TO: Lawrence Haase
FROM: Richard G. Hayman
SUBJECT: St. Augustine Playground
DATE: November 6, 1981

PROPOSED FENCE

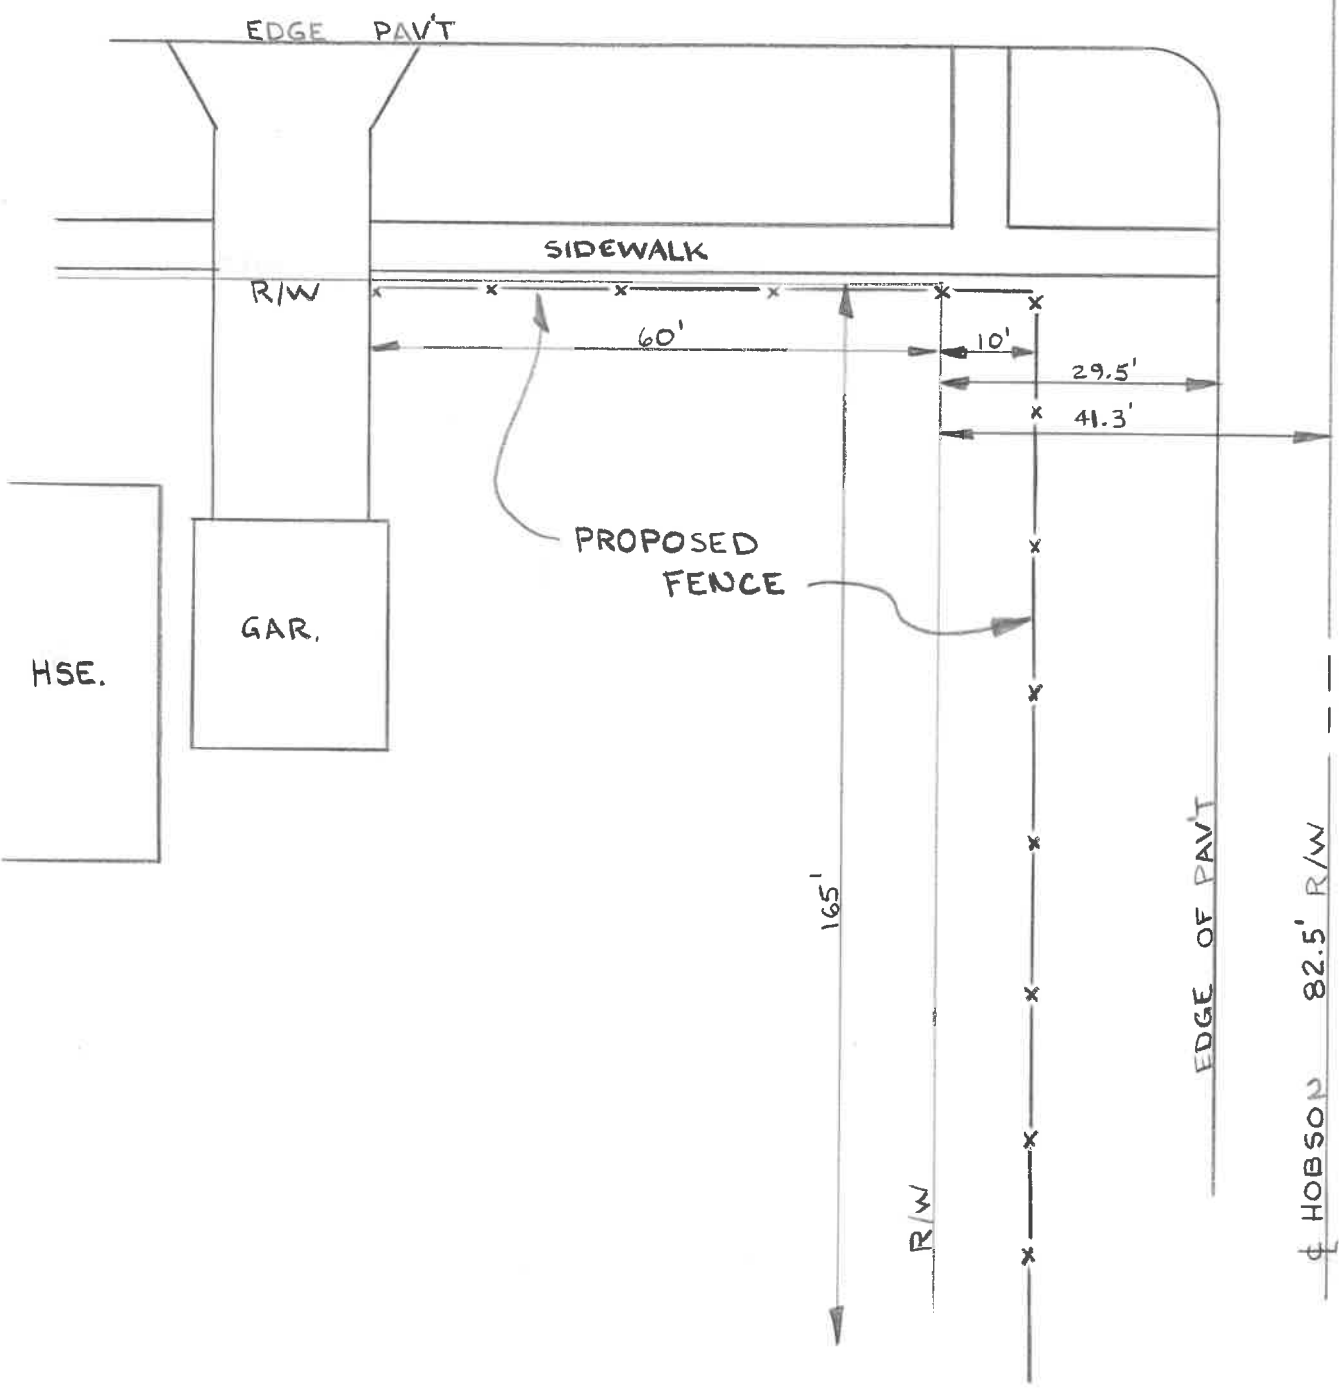
Judy Bauman has asked if a 6 ft. chain-link fence could be placed in the right-of-way along Hobson running south from W. Clinton 165 ft. The right-of-way of Hobson is 82.5 ft. There is 29 ft. of grass from the property line to the edge of the street. They want to place the fence 10 ft. off the property line into the right-of-way.

I am not in favor of anyone placing a fence in street right-of-way. Last year Alan Tandy allowed a property across W. Clinton and to the east to erect a split-rail fence one ft. off the curb. I was not in favor of this and expressed my concern. Allowing this fence in the right-of-way could open a can of worms, if other persons would want a fence. I do not care what way the decision goes but would like to know if Council should rule on this or if I can allow it.
